## ADDENDUM NUMBER ONE

## ROADWAY IMPROVEMENTS FOR EMERSON PARK

STANDARD CONSTRUCTION DETAILS BITUMINOUS PAVEMENT REPLACEMENT DETAIL NUMBER

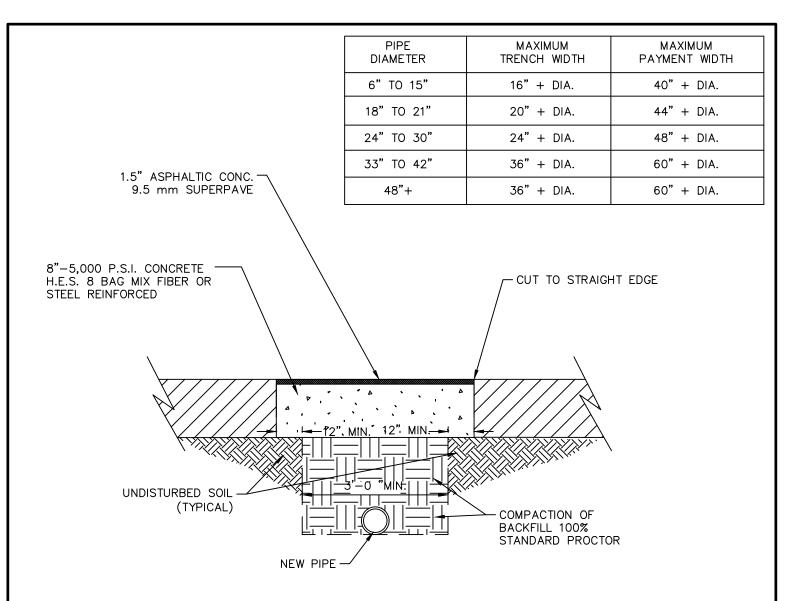
- 1. The question was asked why we were using 4' sections of RCP. The four (4) foot sections of Reinforced Concrete Pipe (RCP) were designed to minimize the quantity of RCP pipe in the project.
- 2. The attached "Bituminous Pavement Replacement" detail should be added to the construction plans.
- 3. Refer to the Schedule of Items and "Section 01150 Measurement and Payment item 2.08 Remove and Replace Fence" in the bid documents for the removal and replacement of existing fence.

100% COMPACTION OF BACKFILL PER COUNTY SPECIFICATIONS ASTM D698

- 1. COMPACT BASE AND SUB-BASE TO 100% STANDARD PROCTOR.
- 2. CONCRETE IN THE RIGHT OF WAY TO BE 5000 PSI AND REINFORCED WITH FIBERMESH OR STEEL.
- 3. ALL LATERAL STREET CUTS MUST BE COVERED WITH STEEL PLATES OF SUFFICIENT THICKNESS TO SPAN THE CUT WITHOUT NOTICABLE DEFLECTION. PLATES TO REMAIN IN PLACE UNTIL THE CONCRETE BASE HAS GAINED SUFFICIENT STRENGTH TO WITHSTAND TRAFFIC LOADS (24 HOUR MINIMUM).
- 4. ALL LONGITUDINAL CUTS EXCEEDING 150' IN LENGTH WILL REQUIRE AN ASPHALT OVERLAY OF THE ENTIRE ROADWAY WIDTH. CONCRETE IN THE TRENCH WILL BE BROUGHT FLUSH WITH THE EXISTING PAVEMENT. PAVING WILL BE SAW CUT TO A STRAIGHT EDGE AND THE ENTIRE WIDTH OF THE ROADWAY WILL BE RESURFACED WITH A MINIMUM OF 1.5" OF 9.5mm ASPHALT SUPERPAVE.
- 5. ALL STREET PATCHES MUST BE SQUARE OR RECTANGULAR WITH STRAIGHT, SAW CUT EDGES.
